UNITED STATES PATENT AND TRADEMARK OFFICE

APPLICATION NO.	FILING DATE	FIRST NAMED INVENTOR	ATTORNEY DOCKET NO.	CONFIRMATION NO.
10/608,701	06/27/2003	Mark V. Vandewalle	5490-000283	9681
27572	7590	09/19/2006	EXAMINER	
HARNESS, DICKEY & PIERCE, P.L.C. P.O. BOX 828 BLOOMFIELD HILLS, MI 48303			ARAJ, MICHAEL J	
			ART UNIT	PAPER NUMBER
			3733

Office Action Summary

DETAILED ACTION

Figure 1

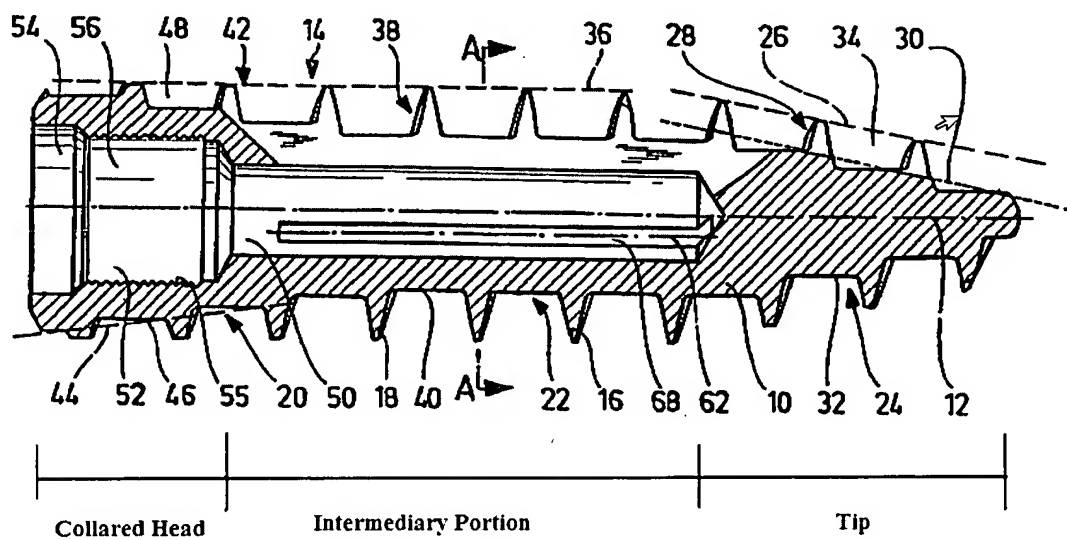
Schultheiss et al. discloses a bone screw anchor (10) that is operable to secure an implant to a bone that has and externally threaded (14) intermediary portion; a pointed self-tapping tip, comprising of a cutting flute that extends across a part of the intermediary portion, located at a first end of said intermediary portion; a collared head, comprising of a cutting flute, located at a second end opposite of said tip that has an interface capable with a driving tool; and a threaded interior (55) bore (50) extending through said head and through said intermediary portion, where it is operable with threads of the fastening device (a screw) to secure the implant to the bone (see Fig. 1 below). Schultheiss et al. also discloses a port (62) on the sides of the anchor that can communicate with the interior bore (50) that is at least partially filled with bone cement, an intermediary portion that is completely threaded that has a larger diameter than the tip and an interface of said head that has at least one recess (54) operable to mate with said driver.

Schultheiss et al. discloses the method steps of securing an implant to a bone which includes implanting a bone screw anchor within the bone using a driving tool operable with the head of the anchor; injecting bone cement into a threaded bore extending through the head to at least a portion of the intermediary portion using a cement delivery device that allows the anchor to be secured; and securing the implant to the anchor using a threaded fastening device secure within the bore. Schultheiss et al. also discloses that the internally threaded portion is inherently protected during the ejecting step, the delivery device is connected to the internal thread of the anchor to protect the threads from being contaminated with bone cement during the injecting step and the bone cement exits at least one port located on the side of the anchor.

Figure 2

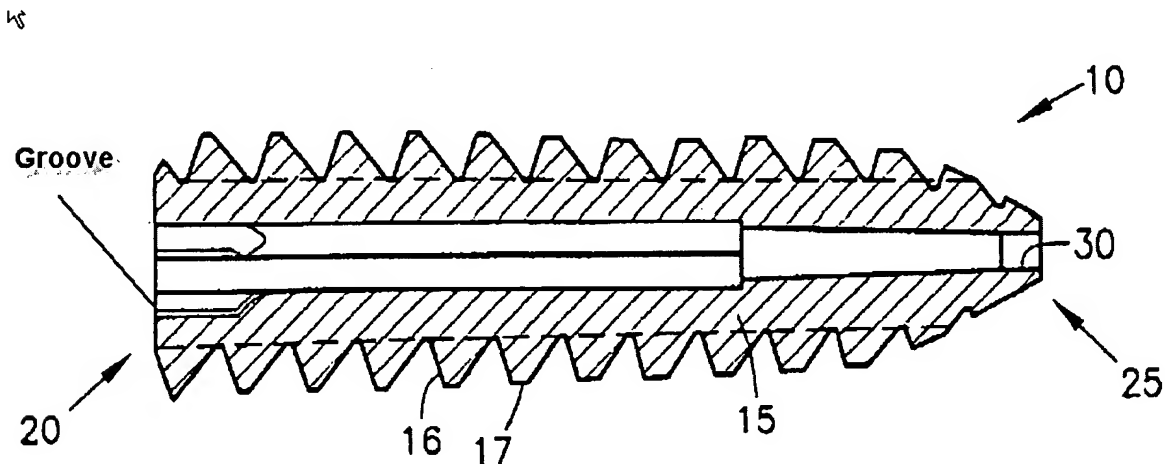
Schultheiss discloses the claimed invention except for and open tip or a screw head having grooves. Wolf discloses a groove to receive a driving tool to optimize

torque capacity when inserting the device. Wolf also discloses an open tip (30) so that a guide pin may be used during delivery and installation. It would have been obvious to one skilled in the art at the time the invention was made to construct the device of Schultheiss with a head defining a groove as well as an open tip in view of wolf, in order to have a device that can be installed with ease and accuracy.
